From: JENKIN, Bernard [REDACTED]@parliament.uk>
Sent: 26 February 2026 10:27
To: Norwich to Tilbury
Cc: CAMPBELL, Daisy
Subject: Deadline 1 - [REDACTED] - Sir Bernard Jenkin
Attachments: National Grid Consultation Bernard Jenkin Response.pdf

Sir Bernard Jenkin MP: Response to Norwich to Tilbury Consultation. July 15th 2024.

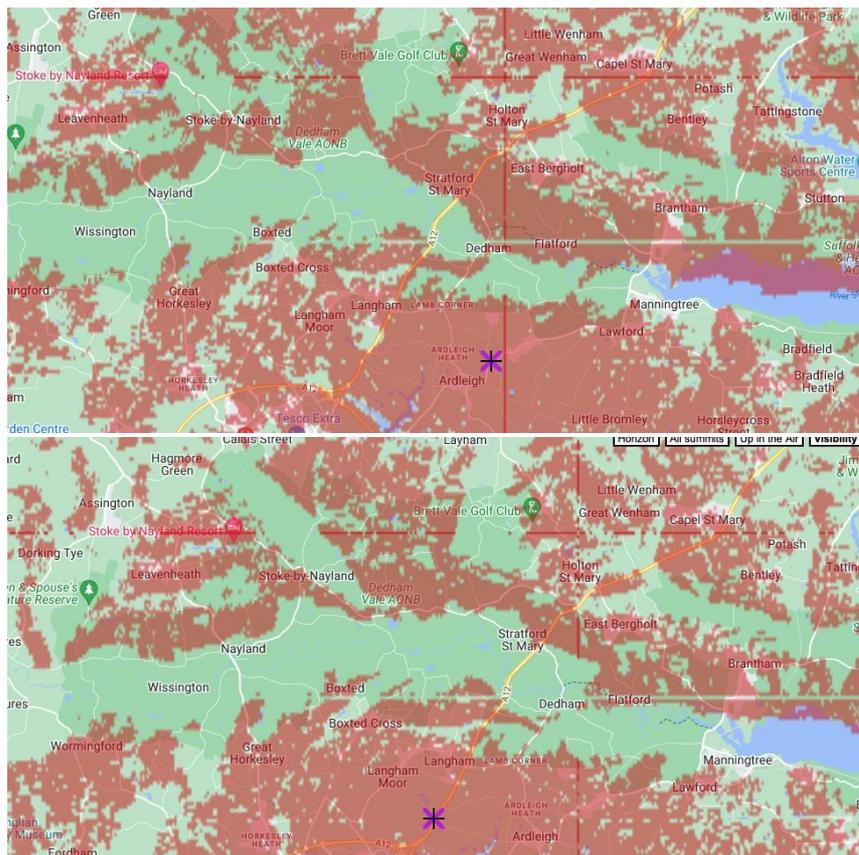
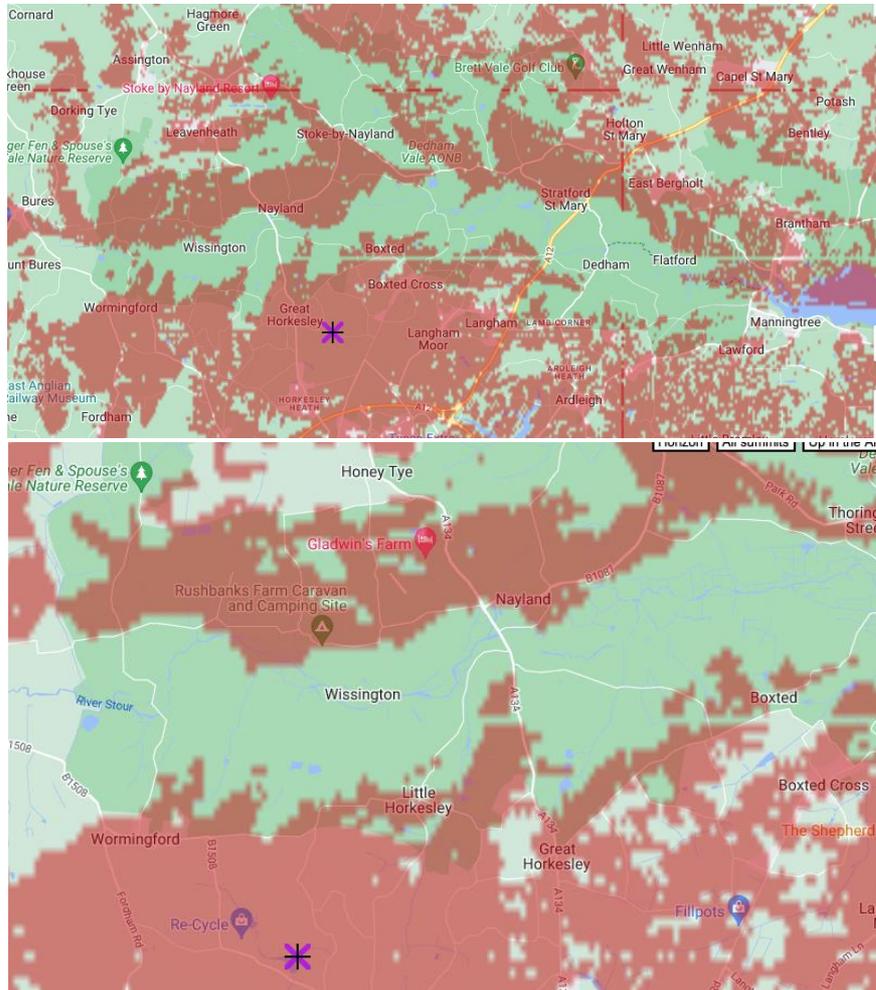
2.3.12 Figure 13.8.1 illustrates that, in the determination of National Grid, “some” pylons will be visible across a large proportion of the Dedham Vale, there are many locations within it from which between 11 and 30 pylons will be visible, and some sites at which between 50 and 60 pylons will be visible.

2.3.13 Figure 13.8.2 illustrates that, in the determination of National Grid, the full structure of pylons will be visible across large portions of the Dedham Vale. These facts taken together suggest that damage will be very significant.

2.3.14 The methodology employed in the construction of these figures is set out at 13.5.4 of the document “Preliminary Environmental Information Report – Volume I – Main Text”, which states: ‘The emphasis of this preliminary assessment is based on landscape and visual receptors within 3km of the operational overground elements of the Project and 1km of the operational underground cable route where it is considered that significant landscape and visual effects are most likely to occur’ and at 13.5.5 which states that ‘More distant viewpoints up to 5km from the Project are considered where there is the potential for significant visual effects to arise beyond the 3km study area, for example where there are particularly sensitive visual receptors and where topography allows more far-reaching views’

- 2.3.15 It is inarguable that a protected National Landscape is a ‘particularly sensitive visual receptor’, it is also inarguable that the pylons and sealing end compounds proposed to the south of the Dedham Vale follow the ridge and lie above the valley in positions from which they are likely to be widely visible. Whilst it is impossible to know which segments of the diagrams include data at 5km as opposed to 3km, the inclusion of some impact at 5km within both figures confirms National Grid’s assessment that the impact within the Dedham Vale arising from infrastructure outside of it along the southern boundary is ‘significant’
